APPLICATION FOR A CERTIFICATE OF APPROPRIATENESS FOR EXTERIOR RENOVATIONS AT 114 WEST ADAMS STREET. THE CARNEGIE SANDUSKY LIBRARY & THE OLD ERIE COUNTY JAIL

Reference Number: PLC 22-0004

APPLICATION FOR A CERTIFICATE OF APPROPRIATENESS FOR EXTERIOR RENOVATIONS AT 404 WAYNE STREET. THE FOLLETT HOUSE & MUSEUM

APPLICATION FOR A CERTIFICATE OF APPROPRIATENESS FOR EXTERIOR RENOVATIONS, DOOR, OUTDOOR SIDEWALK PATIO, WINDOWS, SIGNAGE AT 220 EAST WATER STREET.

PROJECT SCOPE: ITEM 3 - PORCH RAILING

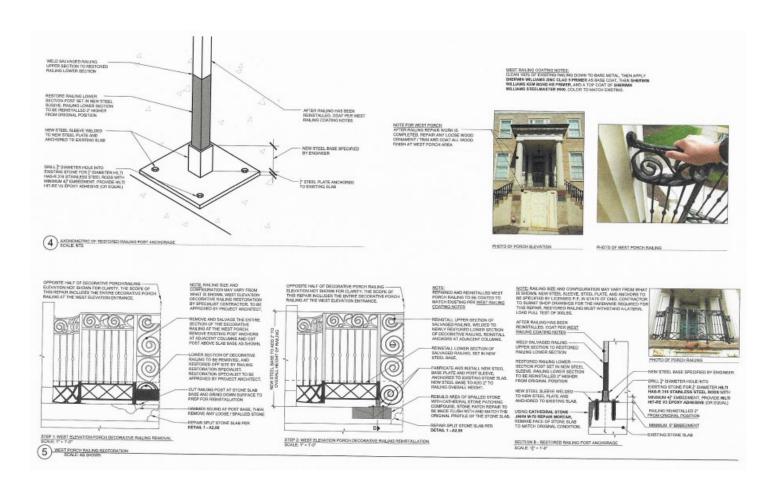
Restoration and reinstallation of second floor front porch decorative railing. The current railing is anchored to the porch floor with posts sunk into the floor slab. This original installation has led to rust and deterioration of the railing and deterioration of the porch floor. The applicant proposes to detach the railing from its current position in order to restore it for reinstallation. The proposed reinstallation includes a new type of anchor using a steel sleeve welded to a new steel plate and anchored to the existing slab (porch floor). This solution will result in the railing to be installed at up to two inches higher than its current position.

SUPPLEMENTAL NOTES / PLANNING DIVISION COMMENTS: ITEM 3 - PORCH RAILING

Staff applauds the undertaking of restoring this iconic piece of the Follet House and the care the applicant has taken to preserve the detailed ironwork of the porch railing. The architect explained why the proposed reinstallation of the railing using a steel sleeve is preferred to attempting to install it in the original fashion by anchoring it into the porch slab, as this led to the deterioration of the porch itself. Staff expressed concern that the aesthetics of the steel sleeve would deter from the character of the railing and expressed preference that the installation be minimalistic, with flush bolts as possible, and match the color of the railing.

Staff recommends the granting of the Certificate of Appropriateness for the proposed porch railing rehabilitation with the following conditions.

1. The steel sleeve installation is minimalistic, and matches the railing design, color, and texture to the extent possible.

Option A:

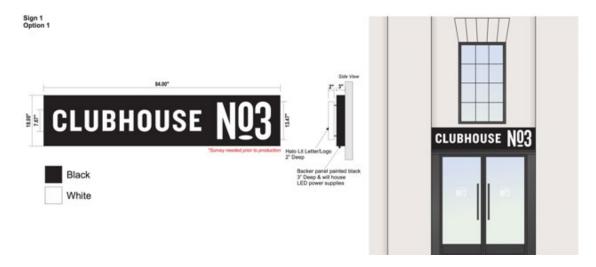
The applicant has came back after further analysis. The sign design and mounting method approved in the 11/17/21 meeting has been updated with concerns from the applicant. The external lighting has stayed the same from the approval.

It is staff's recalation that Commission voted option A down due to the internally illuminated feature, not the overall design. Staff talked with sign provider and confirmed the claim from applicant that approved lettering would require a level surface for application, therefore the historic limestone would need to be sanded smooth in at least three locations for installation. The design with the backing panel can be mounted on unevensurfaces, i.e. onto the existing limestone block, requiring less intervention.

In conclusion, staff recommends the approval of the proposed sign design change at 220 E. Water St. with the following conditions:

- 1. All applicable permits are obtained through the Building Department, Engineering Department, and any other applicable agency.
- 2. The lighting is "halo lit" as originally approved (externally illuminated)

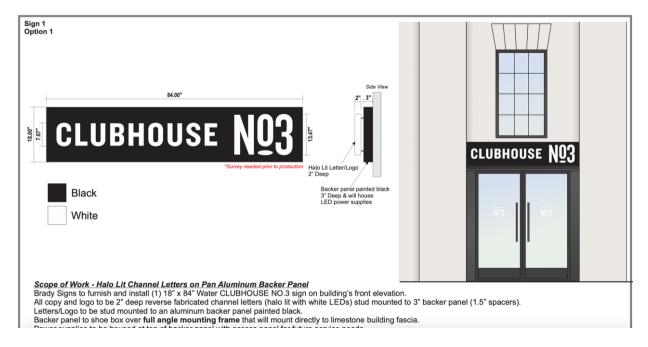
Brady signs came back and suggested an alteration to the design that would allow them to mount in the most least invasive way by attaching the floating "halo, backlit" lettering that was approved onto a flat metal backer panel that could be then bolted through the building building to the inside

wall. This altered version of the sign (pictured below) would also allow for water to flow naturally behind the sign down the rough textured limestone as it would protrude over the limestone. Would this be an acceptable alteration that could be moved forwards so that we can start the manufacturing process of our sign which will take 8-10 weeks.
